Section G: Change Pack

Comm Reference:	2918.2 - MT - PO
Comm Title:	XRN5231 Provision of FWACV Service Detailed Design Change Pack
Comm Date:	18/10/2021

Xoserve Reference Number:	XRN5231
Change Class:	CDSP System Changes - New Service Line
ChMC Constituency Impacted:	<ul style="list-style-type: none">• Shipper Users• National Grid NTS• DNs
Change Owner:	Steve Pownall:0121 229 2671: steve.pownall@xoserve.com

Figure : FWACV Calculation – Process Flow

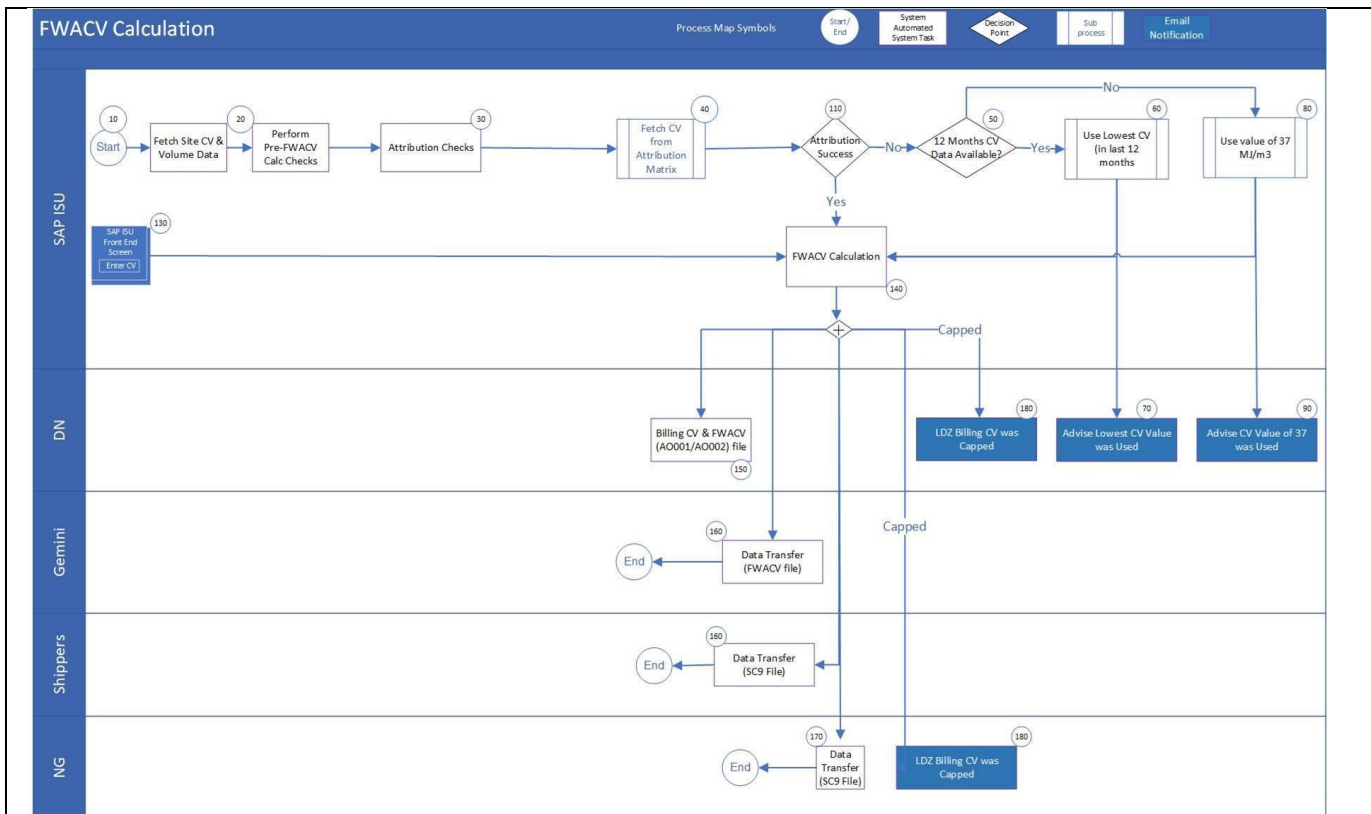
4. FWACV Calculation;

Step 60 - Check when the 12 months start, is this the day prior to the failed CV?

i.e., If today's date is 28th Mar 2019 the lowest CV for the last 12 months should be determined from 27th Mar 2018 to 27th Mar 2019.

<p>Step 110 - Step 120 seems to be missing from the flow diagram or numbered incorrectly.</p> <p>Step 150 - We currently receive this by about 10:40 so we need to maintain this schedule as it supports other processes too.</p> <p>Step 170 - Confirm the LDZ CV is the LDZ billing CV.</p> <p>5. Loss of Record (LOR) Process; Step 60 - Sorry I don't understand this section. Are you sending out an email every time a site doesn't flow? If you are you're going to sending a lot of emails as many offtakes are shut down all summer and report a CV of 35 to show it's not to be included in the FWACV calculation.</p> <p>Step 100 - What format is being used for a range of gasdays? i.e., DDMMYYYY to DDMMYYYY, or each gasday listed individually? - If the LOR covers multiple gasdays will this list the CV's for each gasday?</p> <p>6. Data Migration; - Will this data come to the DN's to be validated, prior to its use? - This would be the offtake/onshore site CV rather than the LDZ billing CV. Will the system exclude CV's of 35 where the site wasn't flowing for the gasday?</p> <p>7. LOR Template; This is missing a section to enter the sample stream i.e., Stream 3 or 4.</p>
